VALUE ENGINEERING STUDY

Project # IM000-0285-01(346) PI No. 713210-

I-75 NB C-D System from Forest Parkway to I-285
Clayton County, Georgia

25 August 2011

R-2.0 Proposed Change 1 of 2

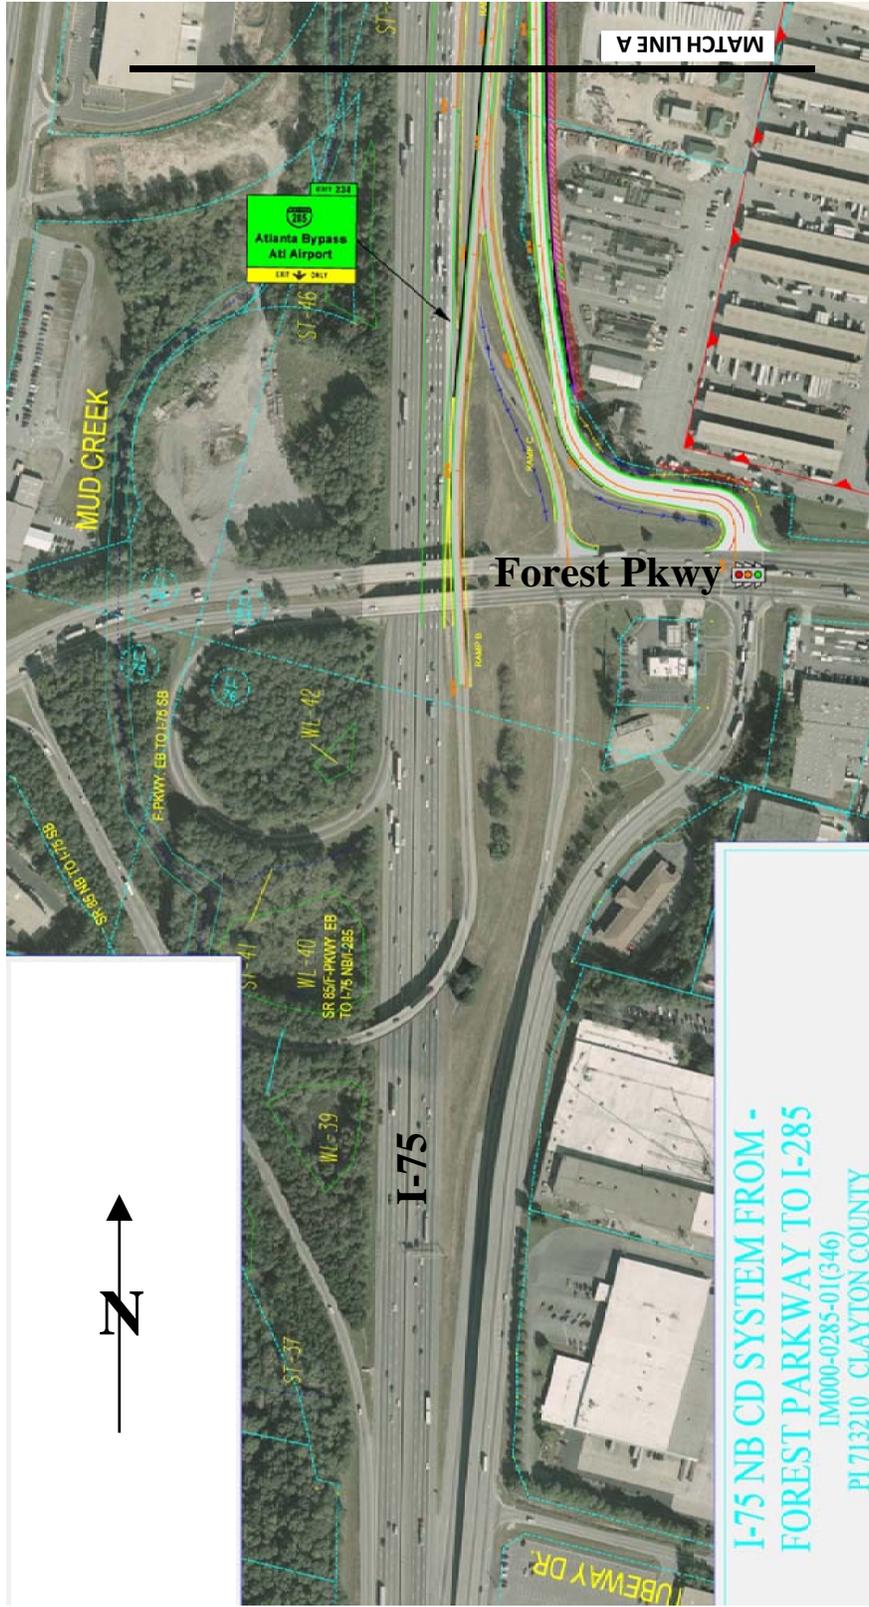
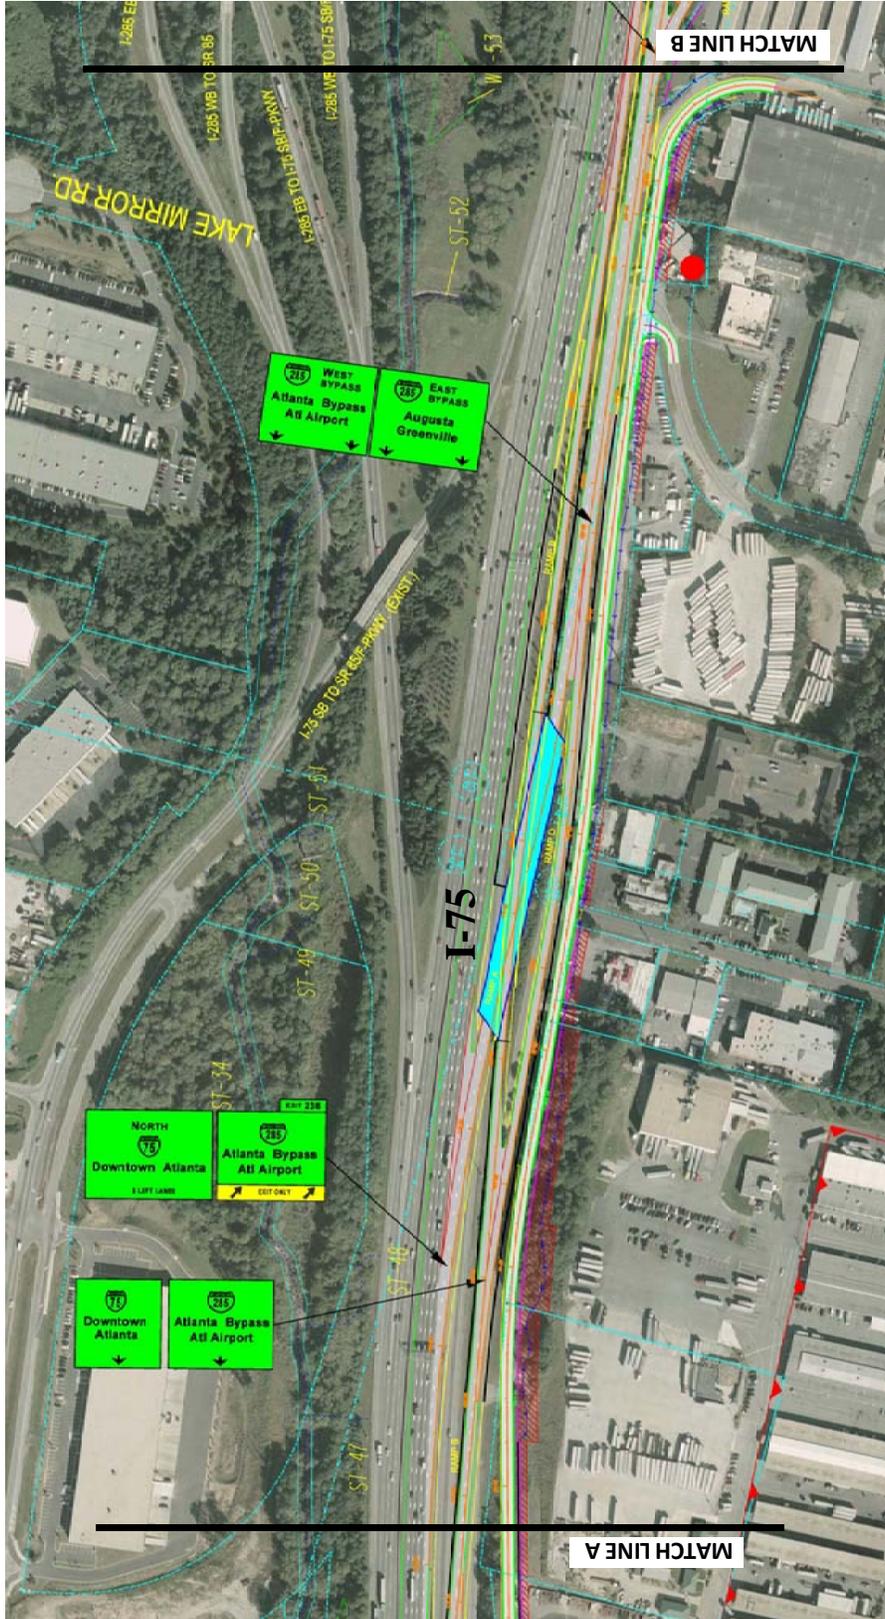
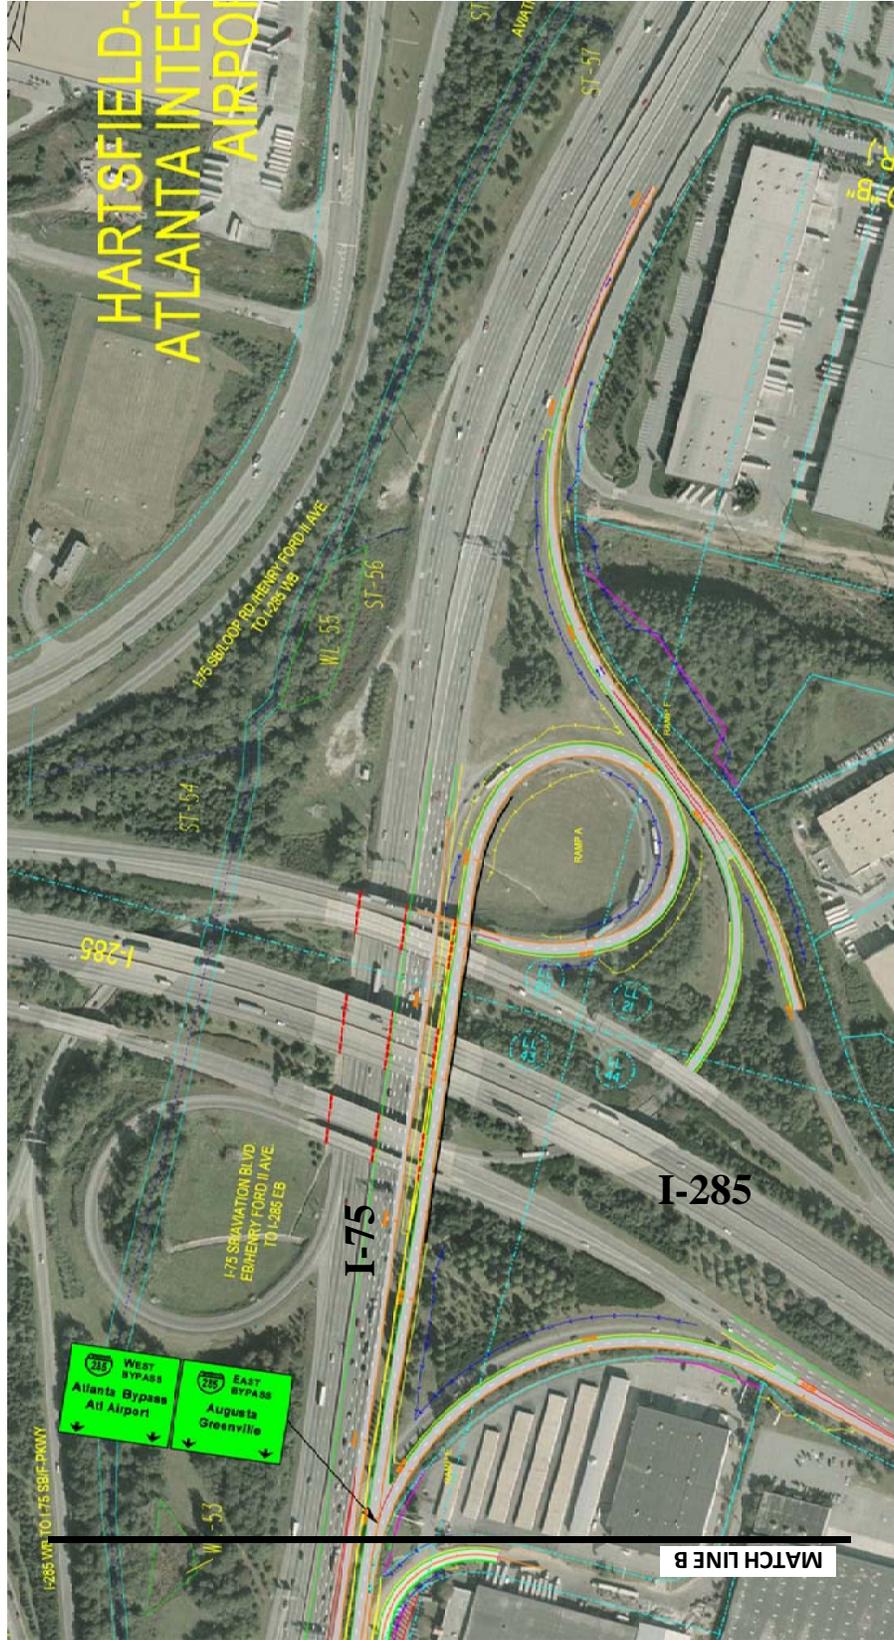
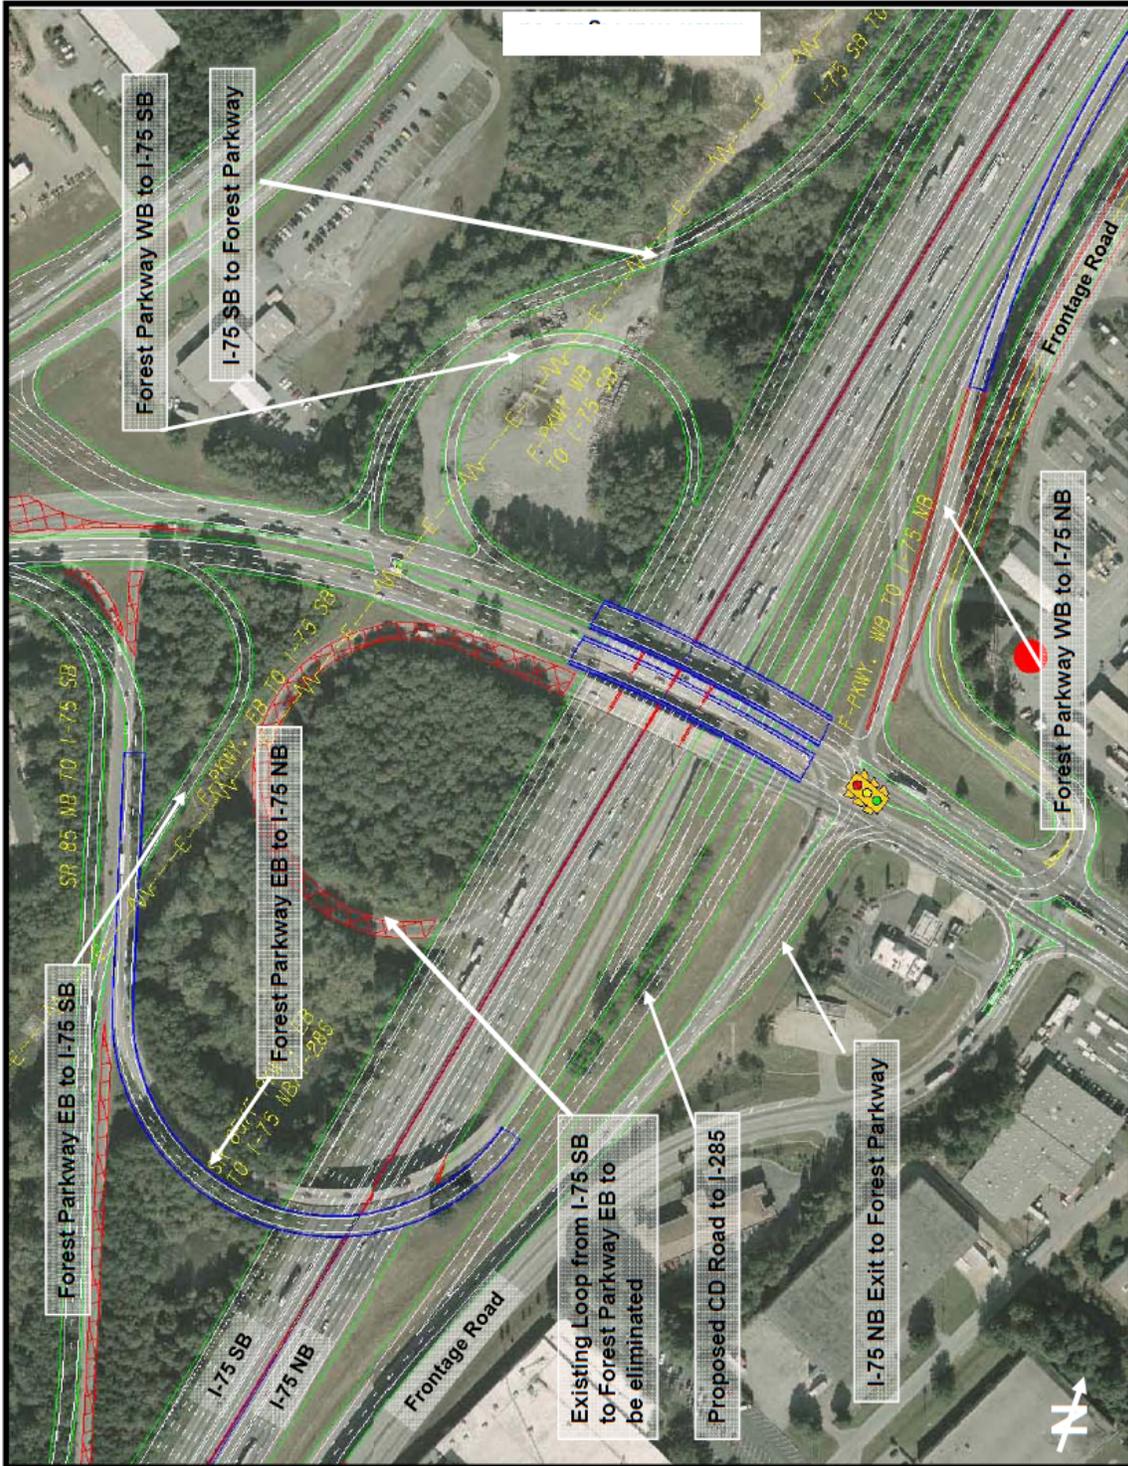
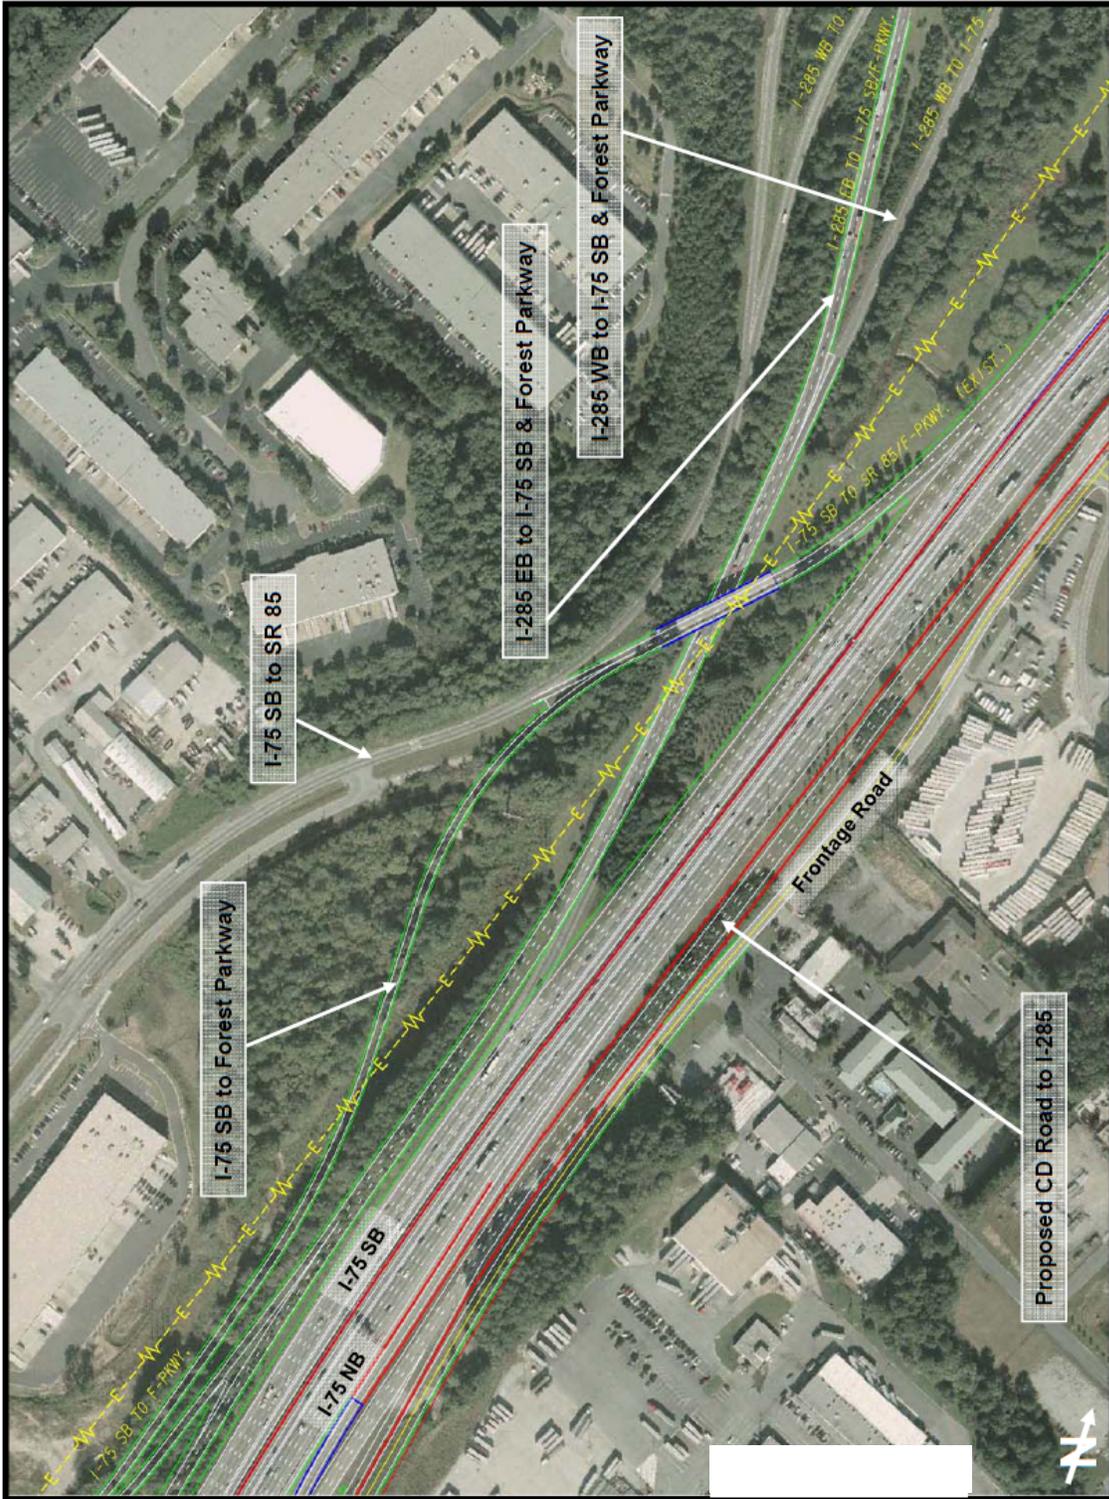
PROPOSED CHANGE: Build out NB C-D Managed Lane Project to include the new Forest Parkway Bridges over I-75 and leaving the existing one-lane SR 85/Forest Parkway EB loop ramp to I-75 NB and the I-75 NB to I-285 WB loop ramp in place. This NB C-D Managed Lane Project would include I-75 NB exiting south of Forest Parkway and merging with the SR 85/Forest Parkway EB loop ramp to I-75 NB to I-285 traffic onto the proposed NB C-D lanes just north of Forest Parkway. Forest Parkway WB on ramp to I-75 NB would bridge over the proposed NB C-D lanes at this point to enter I-75 NB.

Note: Proposed change includes new (lengthened) Forest Parkway bridges over I-75, I-75 NB exiting South of Forest Parkway and merging with Forest Parkway EB loop ramp North of Forest Parkway onto the proposed NB C-D lanes. Forest Parkway WB on-ramp to I-75 NB would bridge over proposed NB C-D lanes to enter I-75 NB

PROPOSAL NUMBER: R-3.0

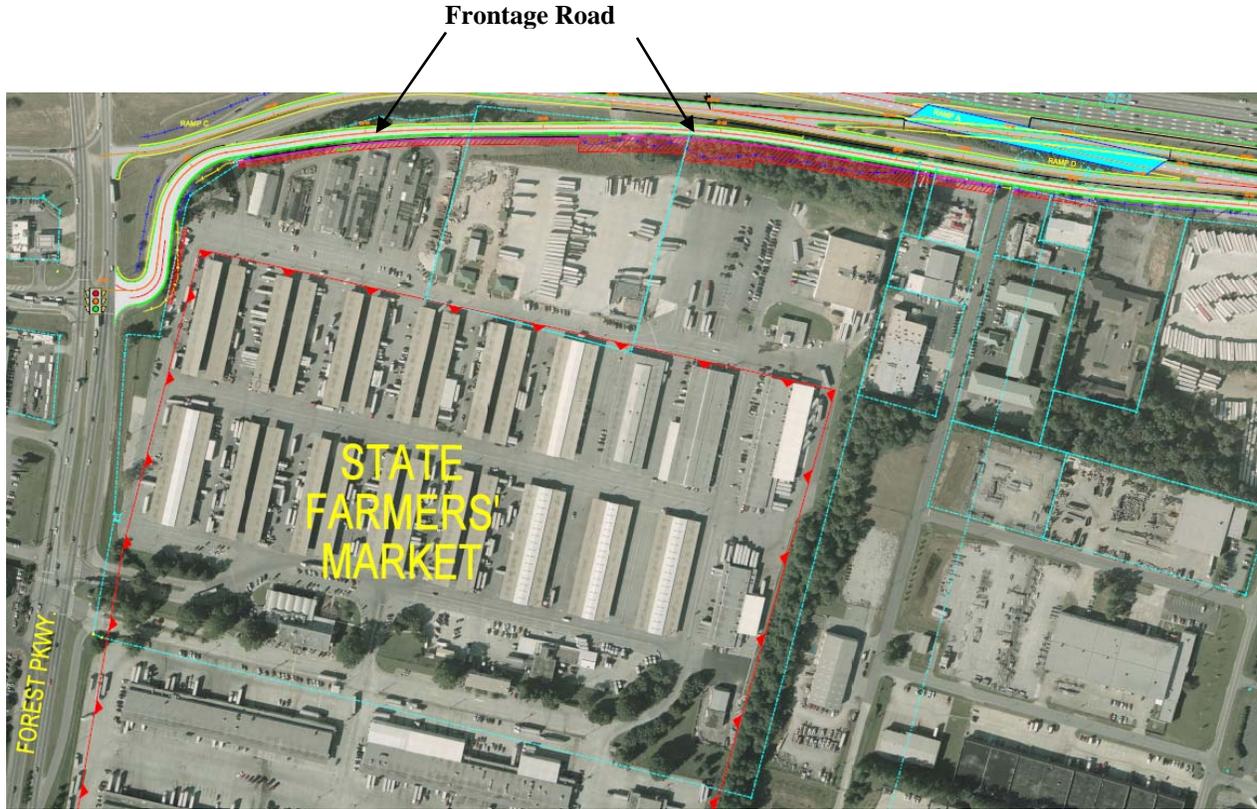
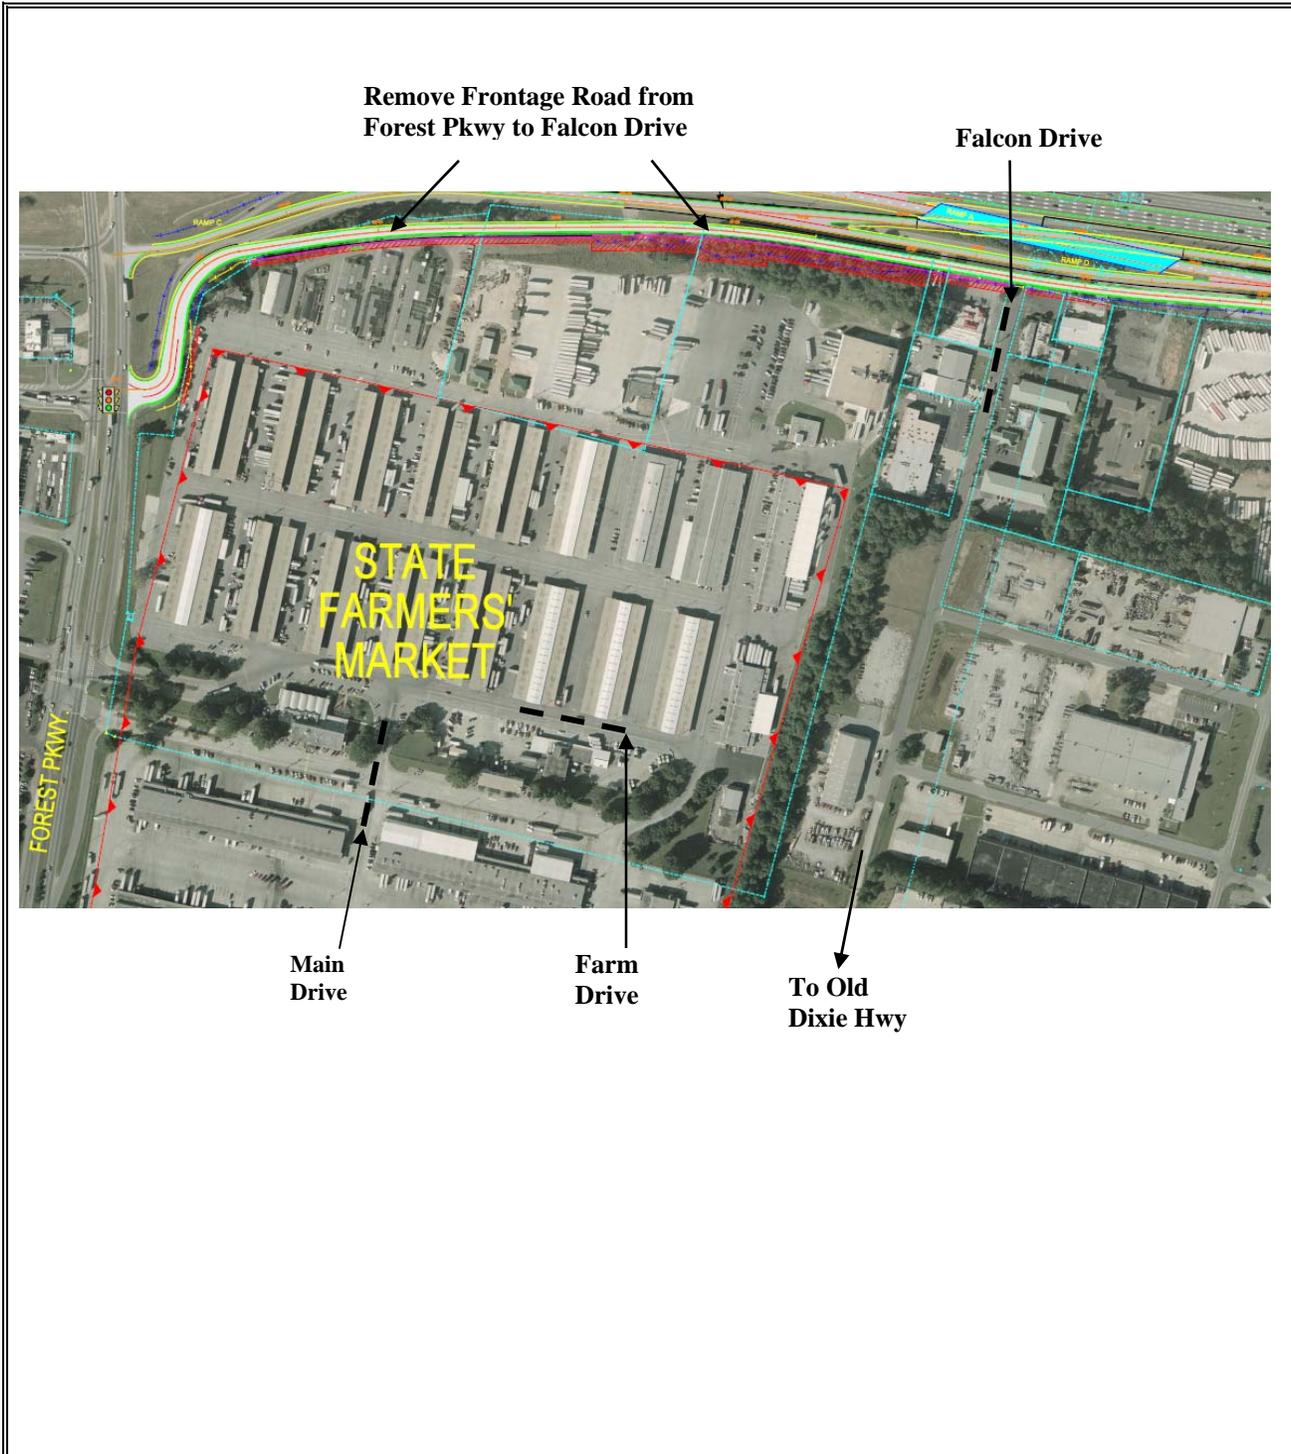
PROPOSED CHANGE: It is proposed to eliminate the New Frontage Road from Forest Parkway to Falcon Drive, including the associated retaining wall.

PROPOSAL NUMBER: R-5.0

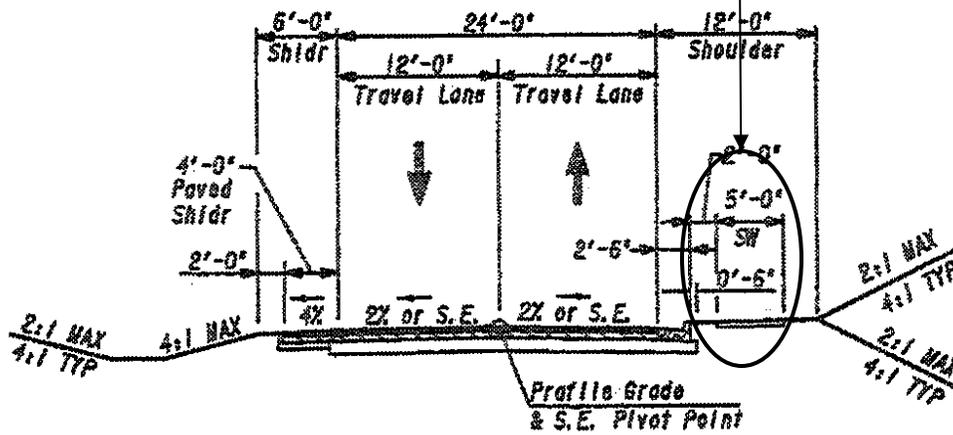
PROPOSED CHANGE: It is proposed to eliminate the proposed sidewalk along the Frontage Road.

Proposed Change: Eliminate Sidewalk
